# HISTORIC AND DESIGN REVIEW COMMISSION

**HDRC CASE NO:** 2017-397  
**ADDRESS:** 415 WILLOW  
**LEGAL DESCRIPTION:** NCB 1653 BLK A LOT N 55 FT OF 17 & 18  
**ZONING:** R-5, H  
**CITY COUNCIL DIST.:** 2  
**DISTRICT:** Dignowity Hill Historic District  
**APPLICANT:** Eduardo Villalon  
**OWNER:** Eduardo Villalon  
**TYPE OF WORK:** Construction of a two story, single family residential structure  
**APPLICATION RECEIVED:** June 29, 2018  
**60-DAY REVIEW:** August 28, 2018  
**REQUEST:**

The applicant is requesting a Certificate of Appropriateness for approval to construct a two story, single family residential structure on the vacant lot at 415 Willow in the Dignowity Hill Historic District.

FRONT ELEVATION  
SCALE: 1/4" = 1' - 0"

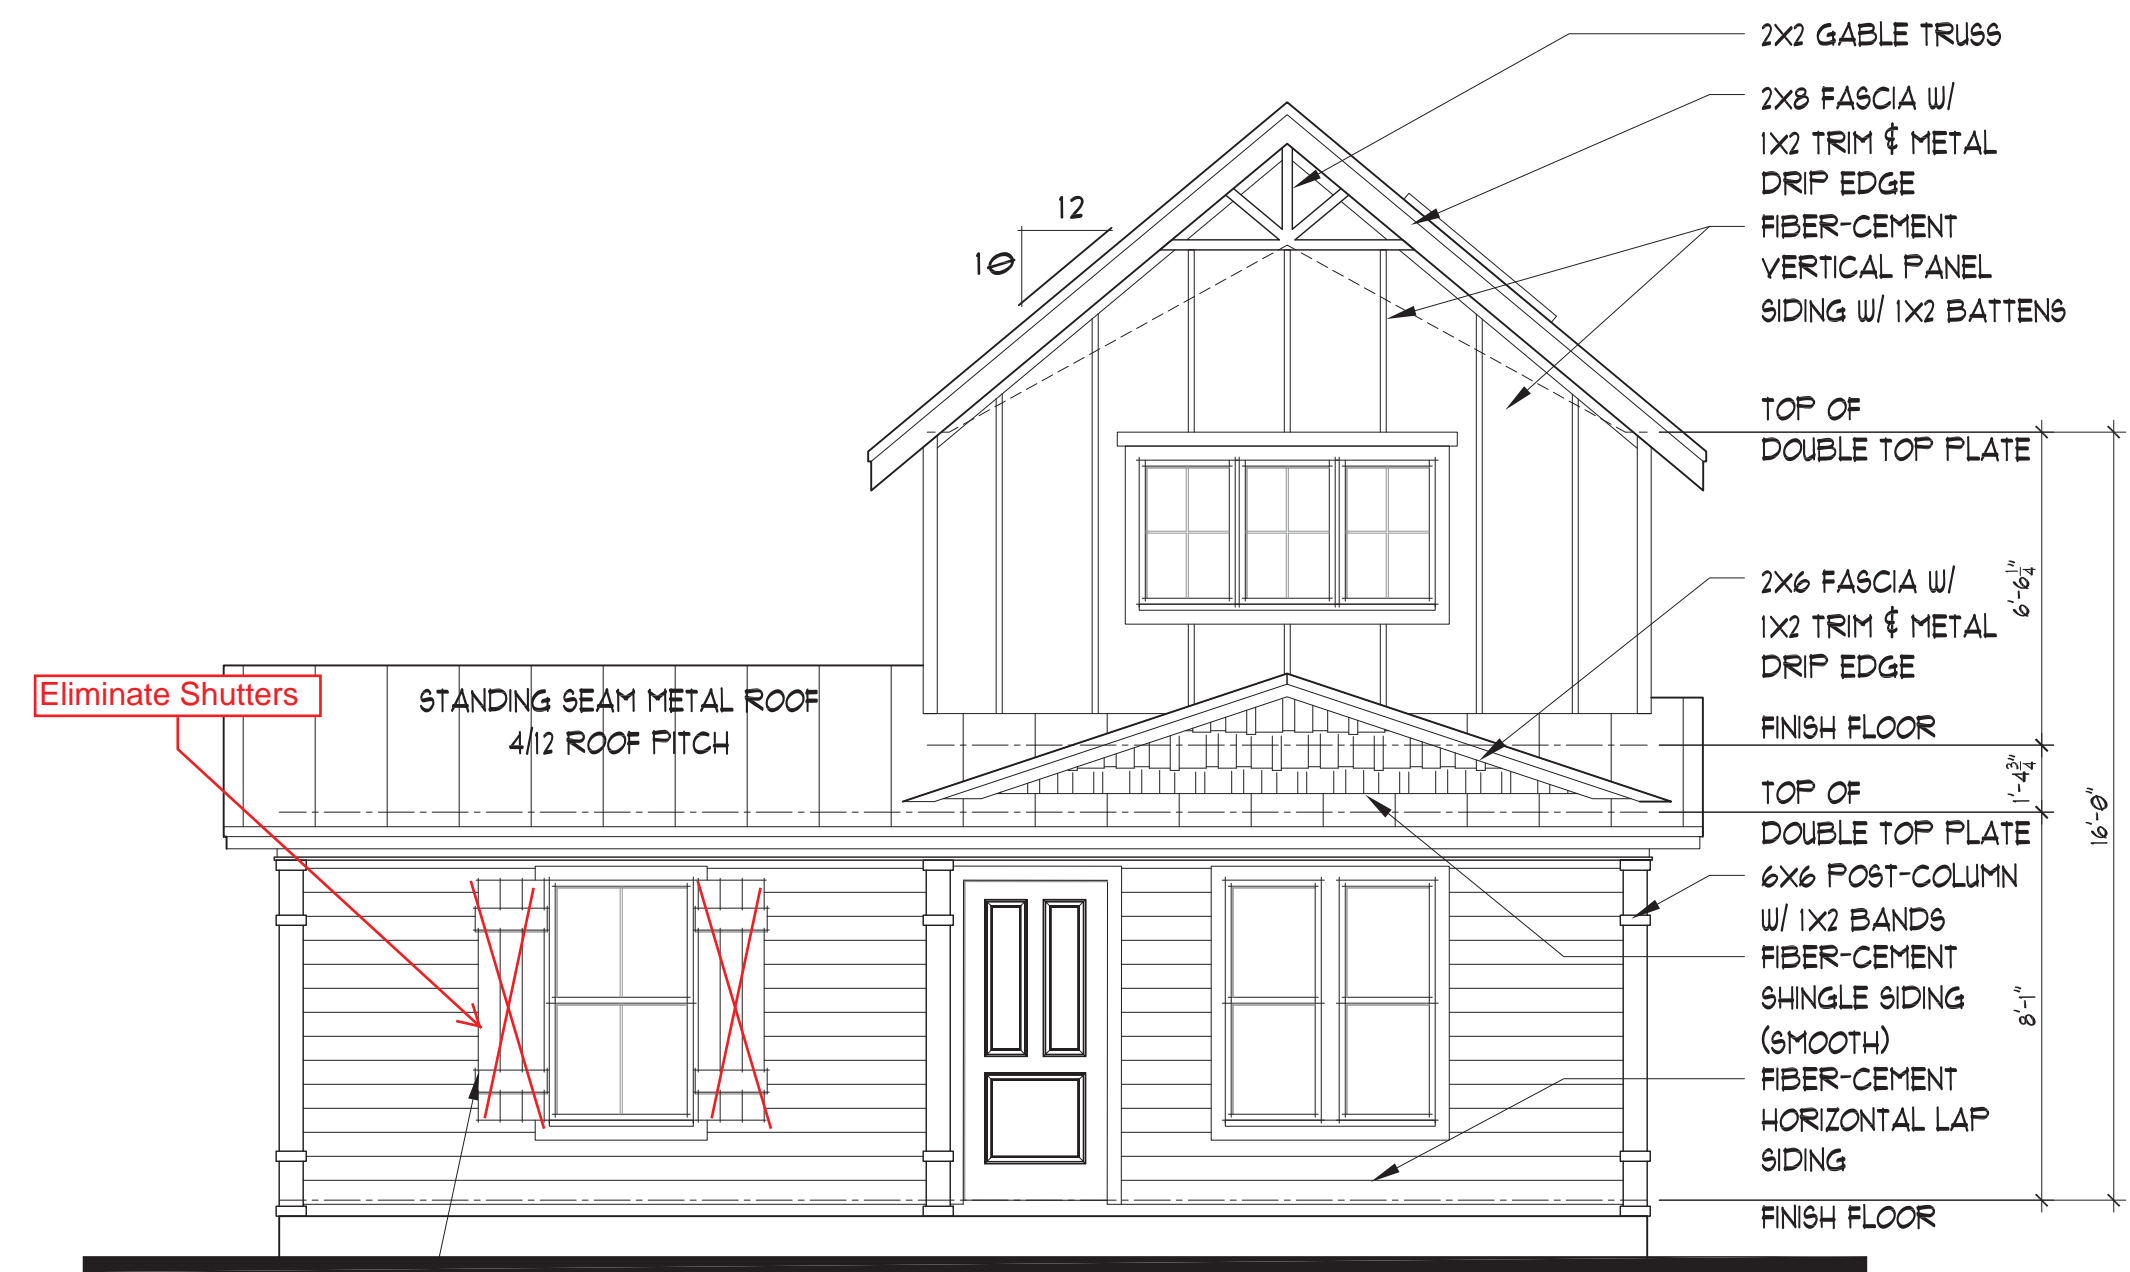
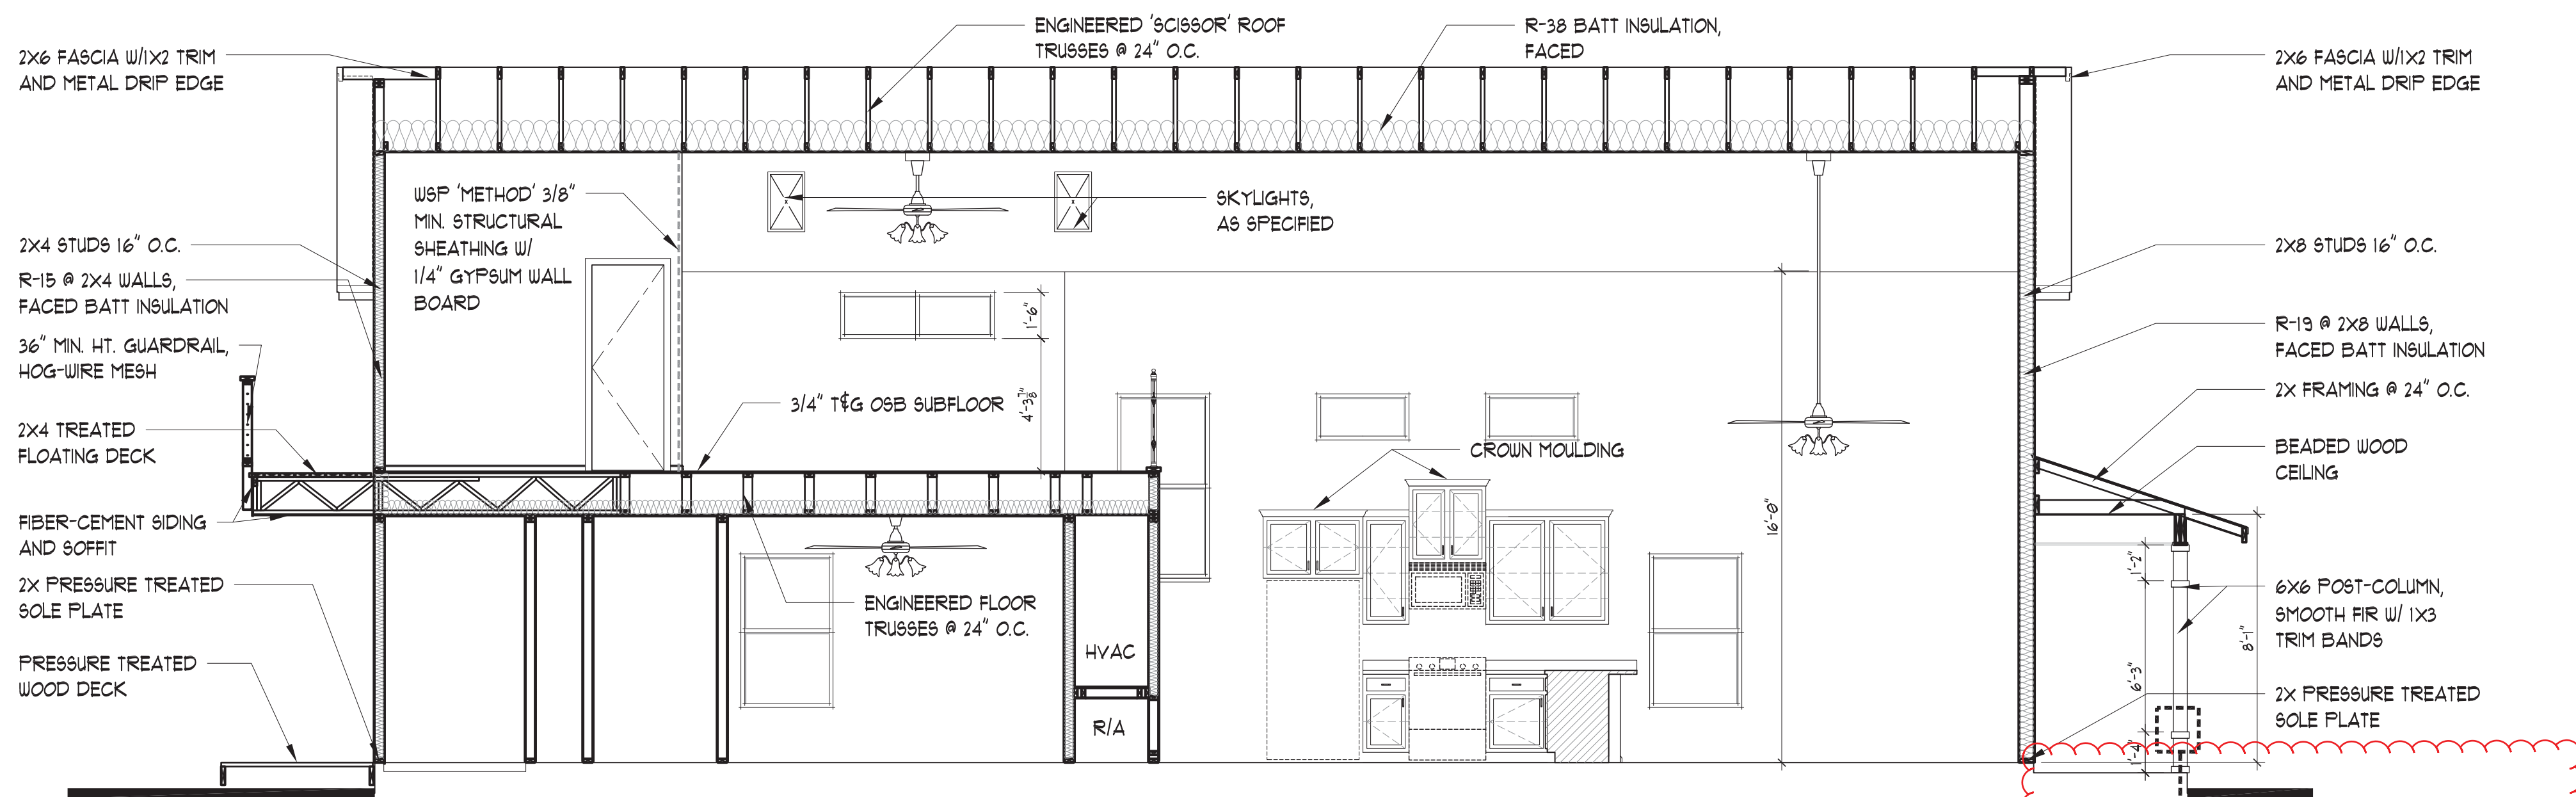
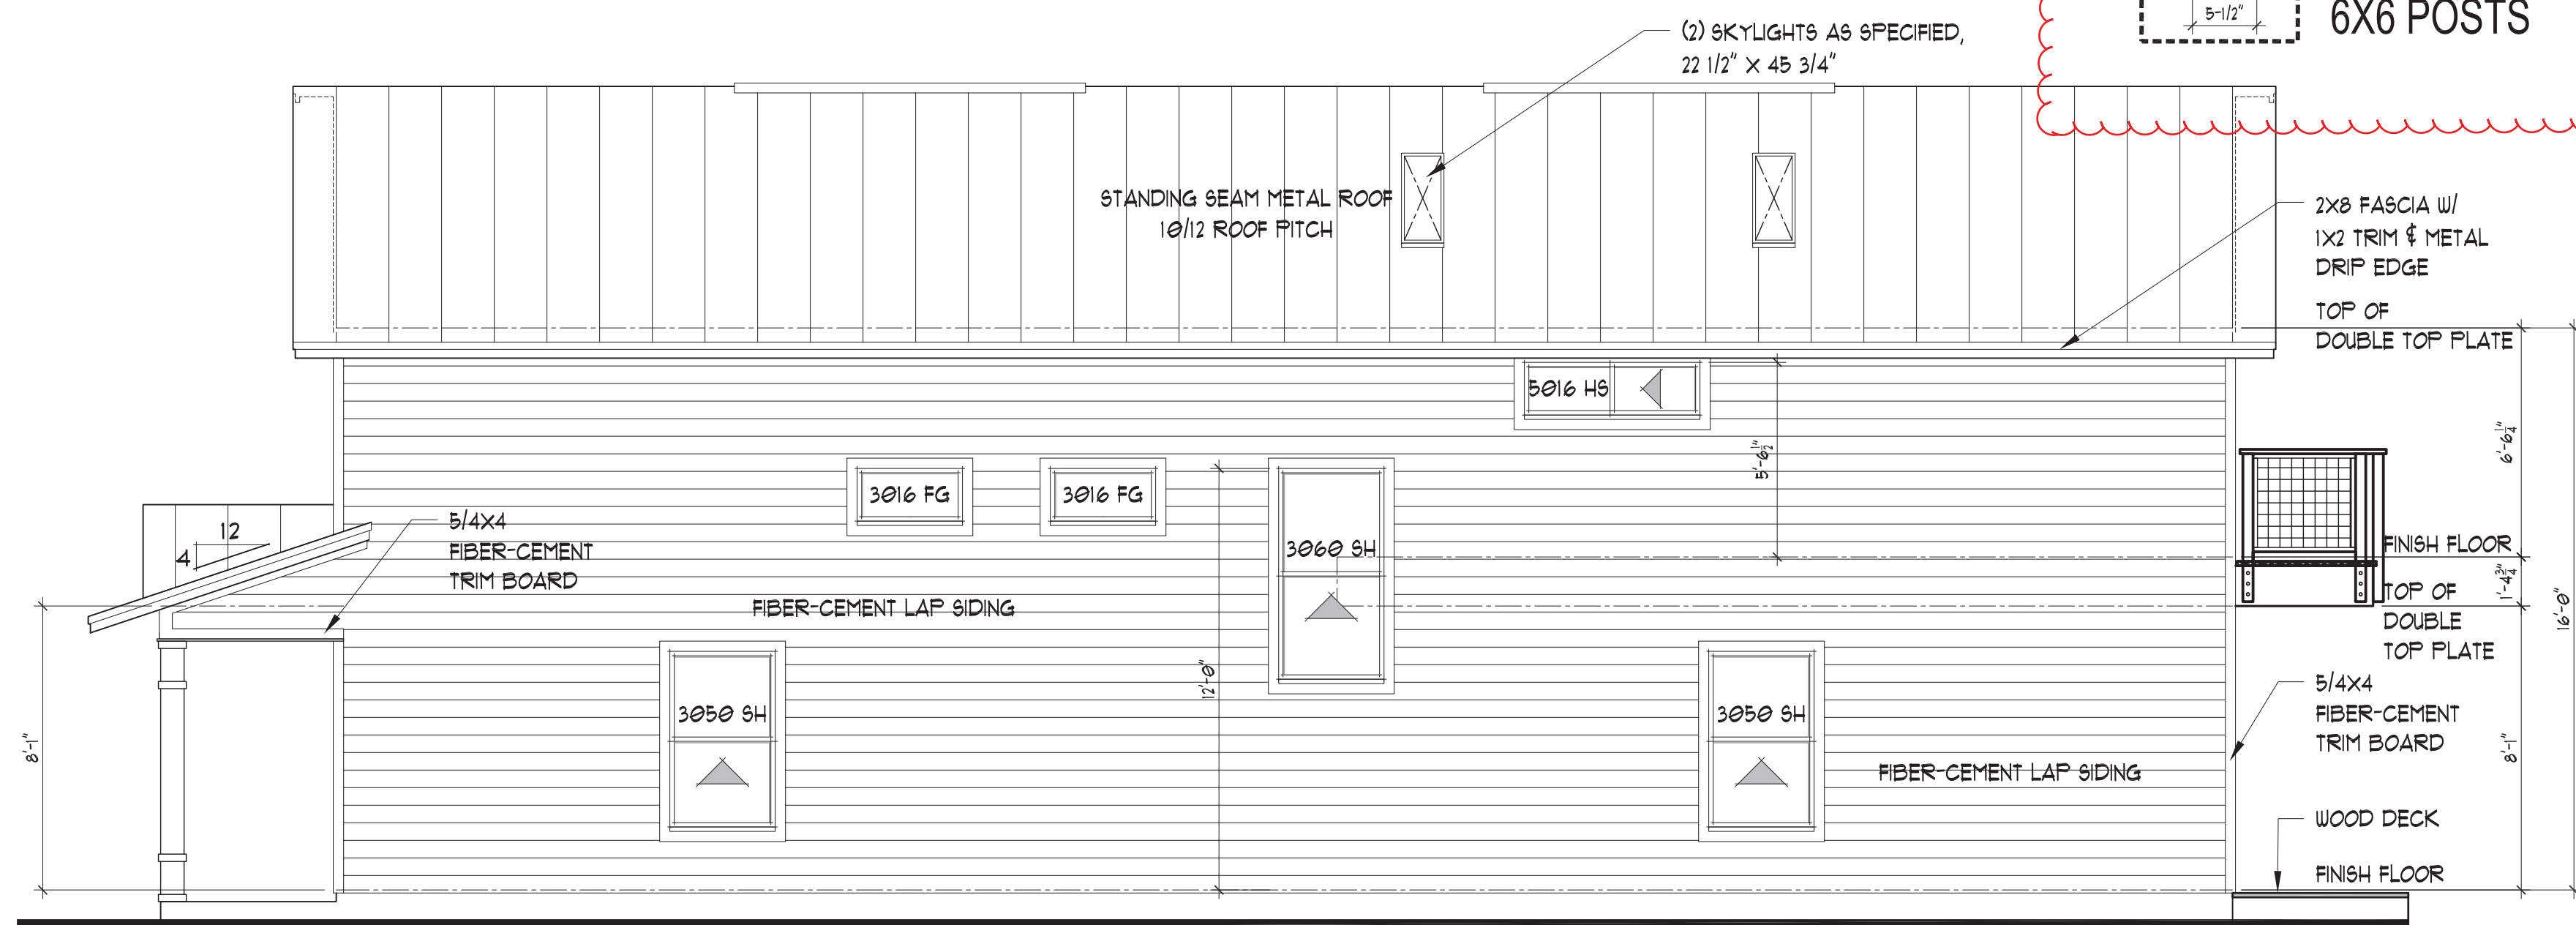
- e. **SCALE & MASS** – Per the Guidelines for New Construction 2.A.i., a height and massing similar to historic structures in the vicinity of the proposed new construction should be used. In residential districts, the height and scale of new construction should not greatly exceed the historic precedent. Each of the three historic structures that are oriented toward Willow as well as the majority in the immediate vicinity feature heights of one story. The applicant has noted a top plate height of 16' – 0" with an approximate seven (7) feet of height from the top plate to the ridge line for an overall height of approximately twenty-three (23) feet. Houses in the immediate vicinity feature one story in height. The applicant has proposed a second story that features reduced massing and a vaulted ceiling to reduce the overall height. Staff still finds that the overall height should be reduced through the shortening of the second story or the lowering of the top plate height to produce an overall height that is comparable with the heights of neighboring, historic structures."

- h. WINDOW & DOOR OPENINGS – Per the Guidelines for New Construction 2.C.i., window and door openings with similar proportions of wall to window space as typical with nearby historic facades should be incorporated into new construction. The applicant has proposed window and door openings that are generally consistent with those found on historic structures in regards to location and size. Since conceptual approval, the applicant has added additional fenestration in the forms of both traditionally sized windows as well as contemporary windows. Staff finds that added fenestration is appropriate; however, their sizes and placements are not.

- k. ARCHITECTURAL DETAILS – New building should be designed to reflect their time while representing the historic context of the district. Additionally, architectural details should be complementary in nature and should not detract from nearby historic structures. While the applicant has incorporated many design elements that are found throughout the Dignowity Hill Historic District, staff finds that the proposed window shutters should be eliminated as they are not found historically in the district.

- i. That the applicant reduce the proposed height through the shortening of the second story or the lowering of the top plate height to produce an overall height that is comparable with the heights of neighboring, historic

- v. That the proposed additional window fenestration be modified to feature windows that feature proportions to those found historically in the district. Windows should feature sashes. Small, fixed windows should not be used.

- vi. That the applicant eliminate the proposed window shutters.
- vii. That the applicant submit a detailed column design noting a width of six inches square and capital and base trim.
